**PLANNED UNIT DEVELOPMENT
& SUBDIVISION STAFF REPORT****Date: November 2, 2017****DEVELOPMENT NAME**Rangeline Crossing III Subdivision, Resubdivision of Lots
4 & 5**SUBDIVISION NAME**Rangeline Crossing III Subdivision, Resubdivision of Lots
4 & 5**LOCATION**(North side of Rangeline Road Service Road 904'± East of
Halls Mill Road)**CITY COUNCIL
DISTRICT**

AREA OF PROPERTY2 Lots / 2.1 ± acres (Subdivision)
7 Lots / 78.3 ± acres (PUD)**CONTEMPLATED USE**Planned Unit Development Approval to amend a
previously approved Planned Unit Development to allow shared access between multiple lots to
accommodate a proposed paint warehouse and retail store.**TIME SCHEDULE
FOR DEVELOPMENT**

SITE PLAN

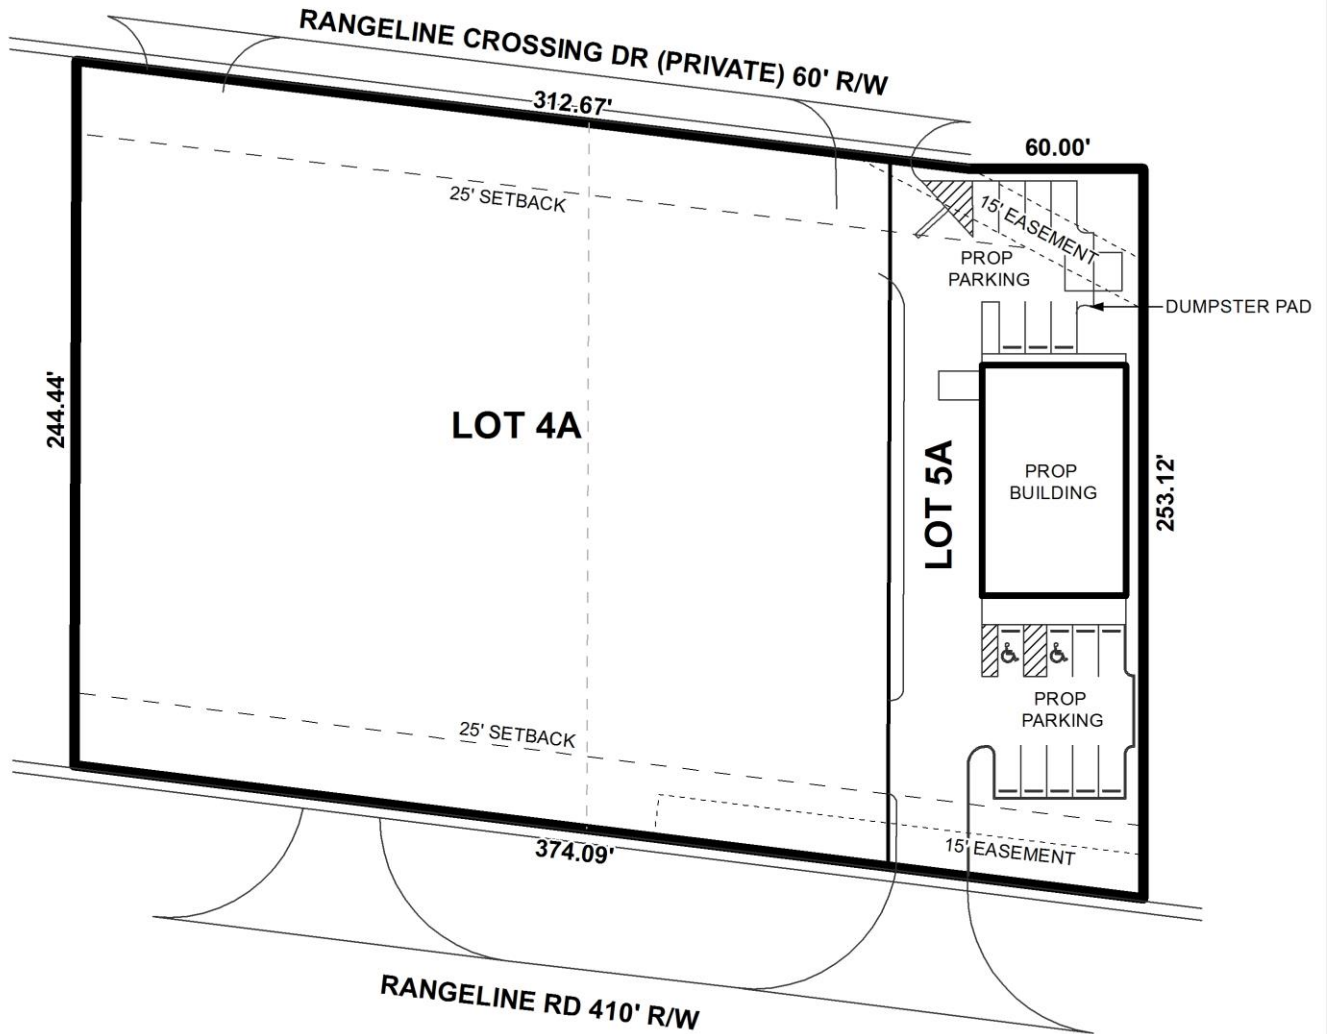
The submitted site plan for the PUD does not include the site plan for the previously approved VA property. The proposed Lot 5A has less than 30' of frontage on the (private) Rangeline Crossing Drive. A standard driveway requires 64' of frontage otherwise the driveway will extend over the property line. The proposed layout of the driveway onto Rangeline Crossing Drive is substandard and not recommended. The plan should include the previously approved VA site and its driveway so that the two designs can be clarified with the PUD approval. Based on comments from ALDOT regarding access on the Service Road, the driveway to Rangeline Crossing should be considered as a shared driveway with Lot 4A and may be better suited to split the property line. The shift of the aisle can provide some relief for the driveway on the north side as well. Confirmation of ALDOT driveway approval will be required prior to permitting for site work on each lot. Enlarged Lot B does not clearly indicate whether the westernmost driveway on Rangeline Service Road is included and may conflict with the overall site layout.

The enlarged plan does not appear to be of the scale reflected on the plan sheet therefore dimensions of driveways, aisles, parking spaces, etc. could not be verified. The revised PUD site plan now appears to include a loading dock on the easternmost lot on Rangeline Service Road. The loading dock appears to obstruct the drive aisle from north to south adjacent to the building. The label on the Lot 4 Specialty Retail should be relocated so that the site layout can be clearly viewed. This arrangement of a drive-thru adjacent to the drive aisle is not desirable (northbound traffic "sandwiched" between two southbound aisles of traffic). Additional separation between the drive aisle and the drive thru is necessary. The westernmost lot appears to include parallel parking that is not clearly identified (looks to be extra long and wide). In conjunction with the drive-thru "bail-out" lane, this area needs to be addressed for right-of-way and functionality, especially if the specialty retail/apparel lot is to share the drive aisle.

The 25' minimum building setback lines are depicted on the site plan and the plat; however, it appears that the setback line does not continue across the entire length of the proposed Lot 5A. the plat and site plan should be revised to depict the 25' minimum building lines for the entirety of both properties.

The revised site plan depicts a shared curb-cut between Lot 4A and Lot 5A to the private Rangeline Crossing and the public Rangeline Road Service Road; however the driveways are not 24' wide. In fact, none of the proposed driveways on Lot 4A are 24' wide, but they depict arrows for two way traffic. It should also be pointed out that Lot 5A appears to have a loading dock on the revised Master Plan, but drive aisle are not depicted. The site plan should be revised to reflect 24' wide driveways and access aisle on all lots.

The site plan also depicts a "site data table" that illustrates "Lot A 3,280 square feet and Lot B 79,040 square feet", however the lots are not clearly identified on the site plan. In fact, there appears to be old lot lines and lot numbers still placed on the site plan. The site plan should be revised to clearly depict, identify, and label all lots and lot lines.

Lastly, it appears that the layout of Lot B resub of Lot 2 has completely changed from all of the previously approved site plans. The parking configuration is different, the building type has

changed, the location of the curb-cuts to the private Rangeline Crossing and the public Rangeline Road Service Road have been altered, and the placement of the dumpster has been relocated and appears to be within the 25' minimum building setback line. The site plan must be revised to clearly depict the dumpster location and 25' minimum building setback line to verify the dumpster is not located in the setbacks.

- 1) revision of the site plan to identify and label all 4 phases on the site plan;
- 2) revision of the site plan to depict all driveways and drive aisles to be 24' wide;

- 3) revision of the site plan to remove all dumpsters out of the 25' minimum building setback line;
- 4) revise the site data table to illustrate each lot's size, the proposed use, square footage of the building, and proposed parking spaces;
